SUBJECT: NRC OBSERVATIONAL SITE VISIT AT THE CANONSBURG,

PENNSYLVANIA, DISPOSAL SITE

Report No.: WM-000042/22-001

## **NRC TRIP REPORT**

Fig. 1: Canonsburg site – Riprap stabilization between site boundary fence and Chartiers Creek (looking north to northwest); image captured on October 26, 2022.

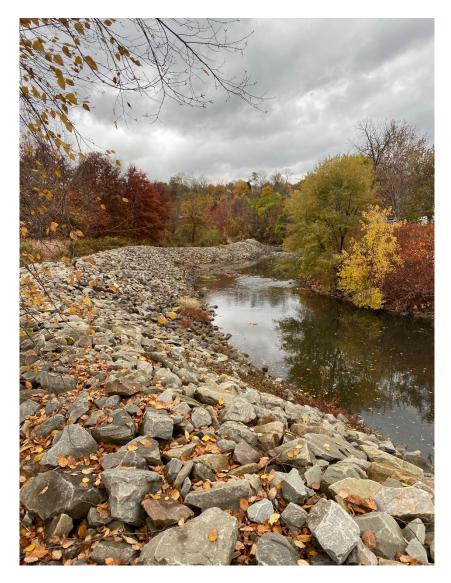
The DOE inspectors checked the disposal cell for evidence of erosion, settlement, slumping, displacement, and any other feature that would require maintenance or repair. The rock surfaces armoring the diversion ditch and the banks of the creek were found to be in good condition. The repairs to the riprap armoring of the stream bank made in 2017 still appear to be in good condition and the strategy to allow a buffer strip of high, dense grass along the stream bank continues to be effective.
